## ***Planning Commission***

**REQUEST:** Approval of Resolution No. 9, Series 2018, a resolution  
recommending approval of a request to extend the  
approved Planned Unit Development for the Louisville Mill  
Site for three years.

# FINAL P.U.D. LOUISVILLE MILL SITE REDEVELOPMENT 500, 540, 544 County Road LOUISVILLE MILL SITE SUBDIVISION LOCATED IN THE SOUTHEAST QUARTER OF SECTION 8, TOWNSHIP 1 SOUTH RANGE 69 WEST OF THE 6TH P.M., CITY OF LOUISVILLE, COUNTY OF BOULDER, STATE OF COLORADO

Sheet  
**A4**  
4 of 4 Sheets

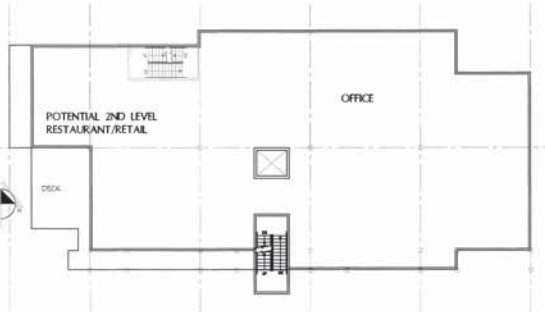
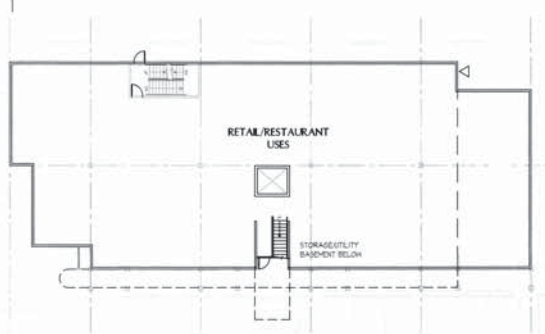
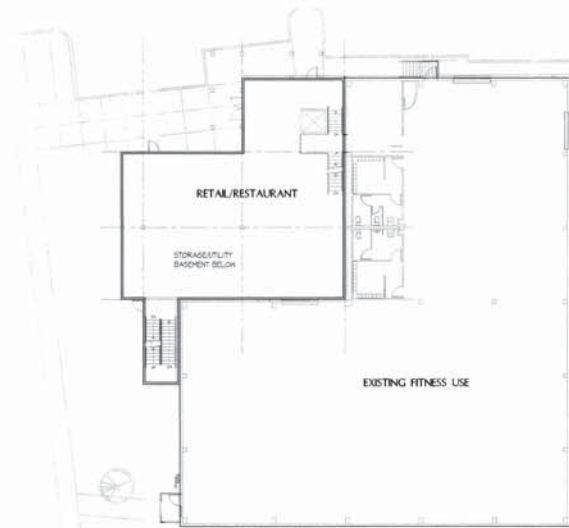
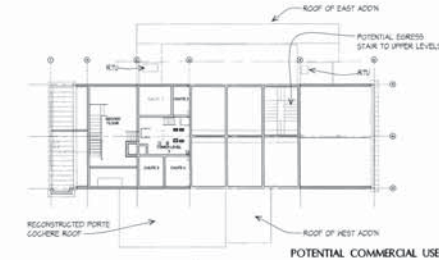
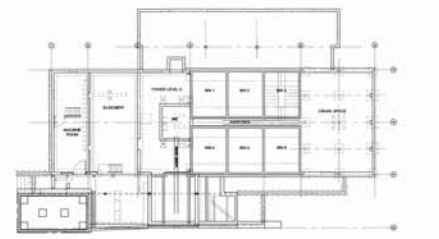
1. On drawing A2, indicate alternative layout of building to include tuck-under parking.
2. Please clarify how ADA access will be provided to Grain Elevator. Drawings of main entrance are not clear.

UTILITY PLAN  
Sheet  
C2.0  
of Sheets

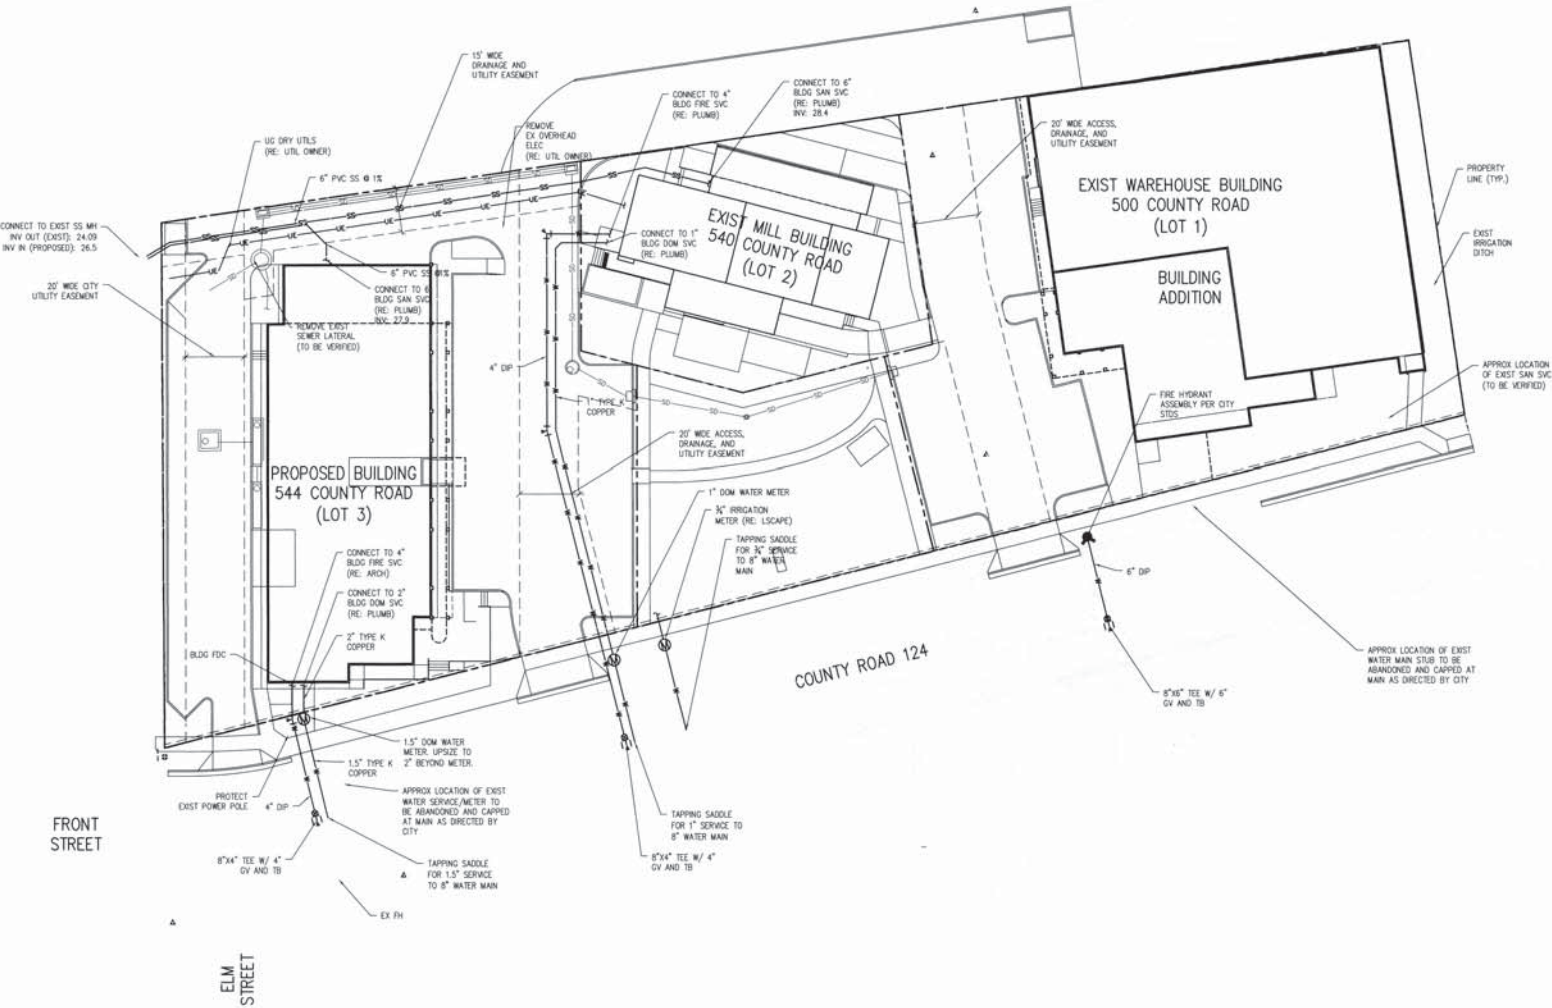
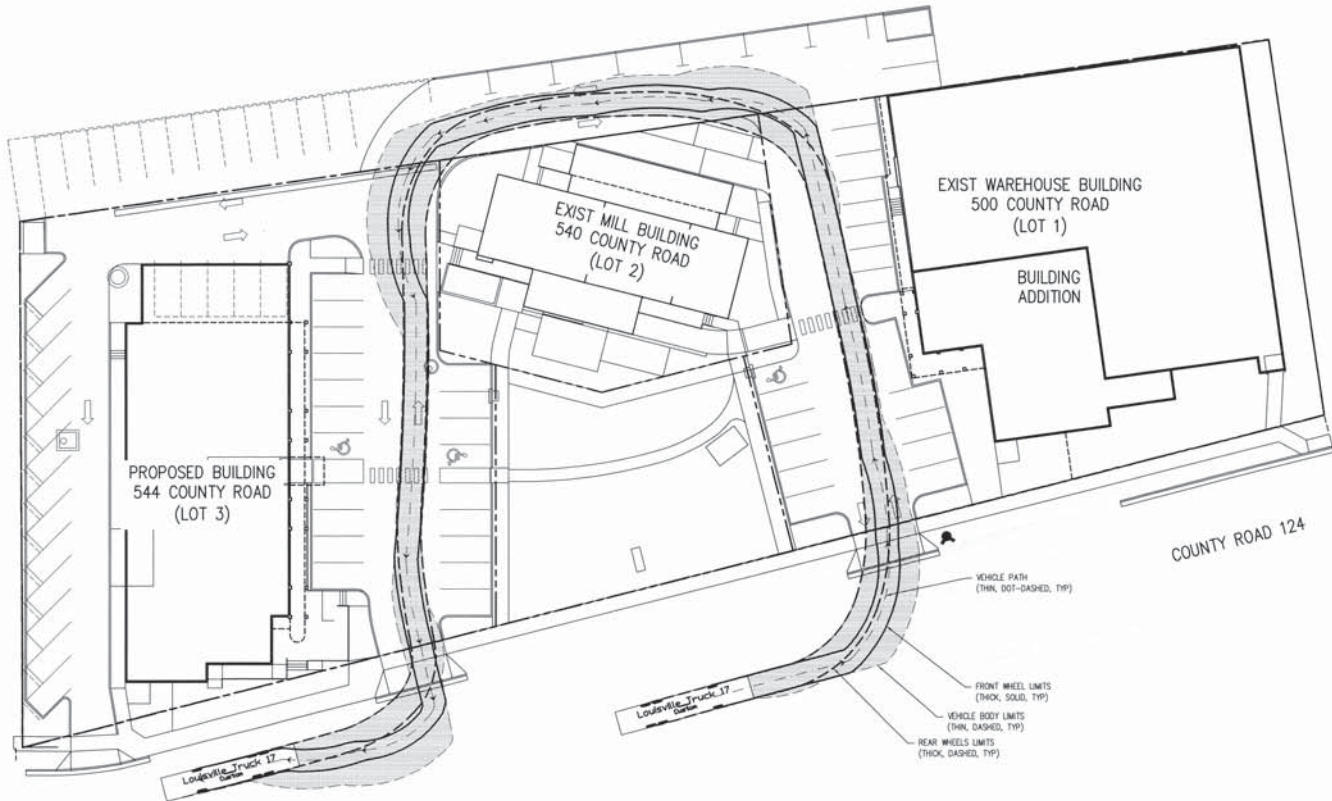
1. The utility plan doesn't show any hydrants on the site. One or more fire hydrants need to be added. Per NFPA 14, the fire department connection must be within 100 feet of a fire hydrant and as shown, they do not meet that requirement.
2. Per the International Fire Code Appendix D, Section D105.2, the fire access is required to be 26' wide for all buildings over 30' and higher.
3. The emergency access plan isn't clear on what the tire track, bumper swing, and bucket swing is. My template shows the fire truck isn't able to make those turns without entering the parking spaces.
